## FIELD OBSERVATION REPORT

Central Hardin High School – Phase 2, 2019111 -CA8

Report No: 40

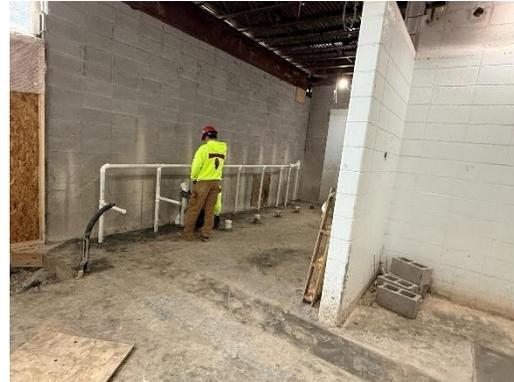
- e) After concerns were raised about the block coursing in recesses for the new classroom doors, remedial work has been done to correct the defects.

It is important for block coursing to align with the tops of the hollow metal door frames in every location.
